BRIARGROVE SUBDIVISION

APPLICATION NUMBER 24 DATE April 2, 2009
 APPLICANT Briargrove Subdivision
 REQUEST Subdivision

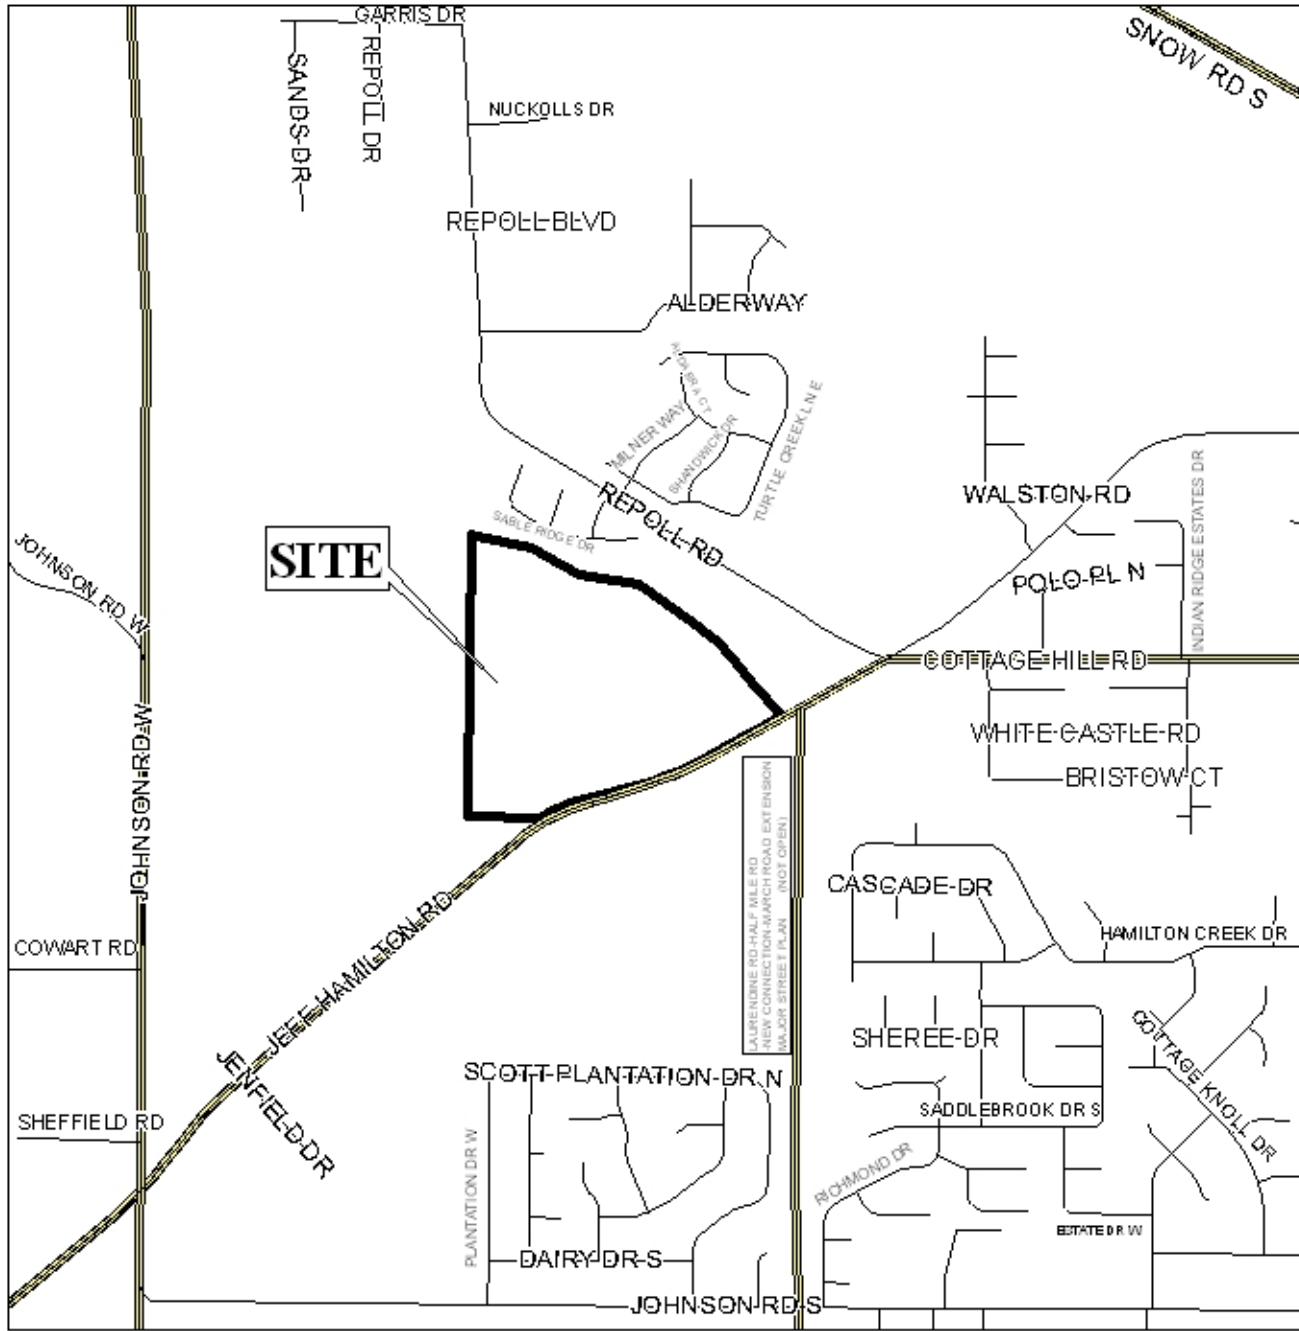
The plat illustrates the proposed 84.4± Acre, 271-Lot subdivision which is located on the West side of Jeff Hamilton Road, 850'+ South of Repoll Road and is located within the planning jurisdiction. The site is served by public water and sanitary facilities.

The site fronts Jeff Hamilton Road, a planned major street having an existing right-of-way of 80-feet. The Major Street Plan, a component of the Comprehensive Plan requires a minimum 100-foot right-of-way; therefore, the dedication of sufficient right-of-way to provide 50-feet from the centerline of Jeff Hamilton Road would be required.

The applicant proposes to create 271 lots, of which approximately 93 lots will “typically” be approximately 5,200 square feet in size, which is less than the 7,200 square feet required by Section V.D.3. of the Subdivision Regulations. The applicant proposes to provide development for these 93 lots as a “patio garden home” section of the overall development. The applicant states that the development would allow 50-percent building site coverage for all lots and reduced side yard setbacks for the smaller (40' x 130') lots. It should be noted that the development illustrates a 1.2 acre park as one of the amenities of the development.

The plat also shows extensive wetlands along Jeff Hamilton Creek which is considered to be wetlands, is present on the site. The potential presence of wetlands indicate that the area may be environmentally sensitive; therefore, the approval of all applicable federal, state and local agencies would be required prior to the issuance of any permits or land disturbance activities.

The application proposes new streets, which must be constructed and dedicated to Mobile County Engineering standards prior to signing the Final Plat. Access management is a concern, due to the location of Lots 1-10, 72-77, 159, 160, 183, and 204-215, should be denied direct access to Jeff Hamilton Road, and since lots 11, 21, 41, 42, 59, 78, 91, 96, 110, 111, 126, 127, 141, 142, 158, 183, 215, 236, 237, 254, 255, and 271 are corner lots therefore, a note should be placed on the Final Plat limiting each lot to one curb cut each, with the size, design and location to be approved by County Engineering.

The proposed 271 lot subdivision will have two connections to Jeff Hamilton Road, and provide another street stub to undeveloped property to the West

Detention/retention and common areas are depicted on the preliminary plat; therefore, a note should be placed on the Final Plat stating maintenance of these areas will be the responsibility of the property owners.

With a waiver of Sections V.D. 2. and V.D.3. of the Subdivision Regulations, the plat meets the minimum requirements of the Subdivision Regulations and is recommended for Tentative Approval subject to the following conditions:

- 1) dedication of sufficient right-of-way to provide 50-feet from the centerline of Jeff Hamilton Road;
- 2) the approval of all applicable federal, state and local agencies for wetlands prior to the issuance of any permits or land disturbance activities;

- 3) certification via placement of a note on the plat stating that the property owner/developer will comply with all local, state and federal regulations regarding endangered, threatened or otherwise protected flora and fauna;

- 4) the placement of a note on the final plat stating that the development will be designed to comply with the storm water detention and drainage facility requirements of the City of Mobile storm water and flood control ordinances, and requiring submission of a letter from a licensed engineer certifying that the design complies with the storm water detention and drainage facility requirements of the City of Mobile storm water and flood control ordinances prior to the signing of the final plat. Certification is to be submitted to the Planning Section of Urban Development and County Engineering;

- 5) the placement of a note on the Final Plat stating that Lots 1-10, 72-77, 159, 160, 183, and 204-215, be denied direct access to Jeff Hamilton Road and allowed one curb cut to the new street, with the size, design and location to be approved by Mobile County Engineering Department;

- 6) the placement of a note on the Final Plat stating that Lots 11, 21, 41, 42, 59, 78, 91, 96, 110, 111, 126, 127, 141, 142, 158, 183, 215, 236, 237, 254, 255, and 271 are corner lots therefore, a note should be placed on the Final Plat limiting each lot to one curb cut each, with the size, design and location to be approved by County Engineering.

- 7) revision of the plat to label the lot with its size in square feet, or placement of a table on the plat with the same information;
- 8) the placement of a note on the final plat stating that any lots which are developed commercially and adjoin residentially developed property must provide a buffer, in compliance with Section V.A.7 of the Subdivision Regulations; and

- 9) placement of a note on the plat stating that maintenance of the detention and common areas is the responsibility of the subdivision's property owners.
